Access Compliance Report Public Rights-of-Way (Curb Ramps)

Main Street: IRON_HORSE_TRAIL		Cross Street: HALF_MOON_TRAIL		Location:	E
ADA ID: RPRK211021131648	Ramp Type: Type 4 - Parallel	Initial Pass/Fail: Fail	Overall Compliance: No	Severity Score:	15

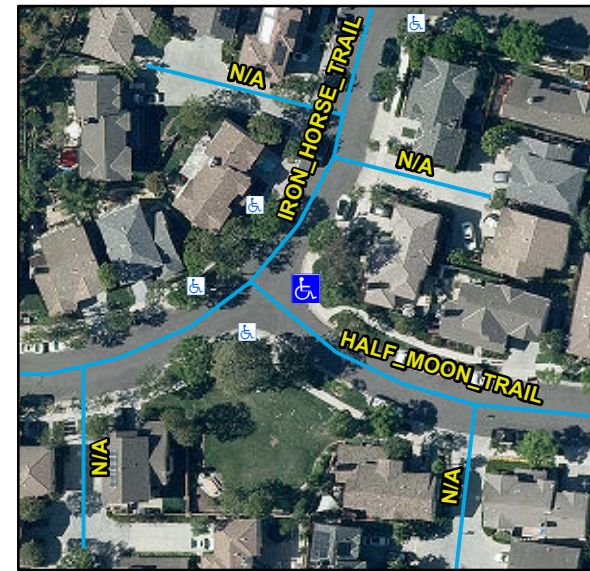
Compliance	Description	Data	Compliance	Description	Data
N/A	Ramp Length LT (in)	92	N/A	Ramp Length RT (in)	90
Yes	Ramp Width LT (in)	53	Yes	Ramp Width RT (in)	52
Yes	Ramp Run Slope LT (%)	3.2	No	Ramp Run Slope RT (%)	10.3
Yes	Ramp Cross Slope LT (%)	1.1	Yes	Ramp Cross Slope RT (%)	1.9
N/A	Landing Present	N/A	N/A	DWS Provided	N/A
N/A	Landing Length (in)	N/A	N/A	DWS Contrast	N/A
N/A	Landing Width (in)	N/A	N/A	DWS Length (in)	N/A
N/A	Landing Run Slope (%)	N/A	N/A	DWS Full Width	N/A
N/A	Landing Cross Slope (%)	N/A		DWS Offset Type	N/A
N/A	Landing Movement Obstructed?	N/A	N/A	DWS Offset Left (in)	N/A
	Landing Movement Type	N/A	N/A	DWS Offset Right (in)	N/A
N/A	Landing Shared	N/A			
N/A	Clear Space	Yes			
N/A	Clear Space To Crosswalk (in)	N/A			
N/A	Marked Crosswalk 1	No	N/A	Marked Crosswalk 2	No
	Crossing 1 Direction	NW		Crossing 2 Direction	SW
N/A	Marked Crosswalk 1 Width (in)	N/A		Marked Crosswalk 2 Width (in)	N/A

Remove & Replace Curb Ramp With Two New Directional Ramps or Equivalent.
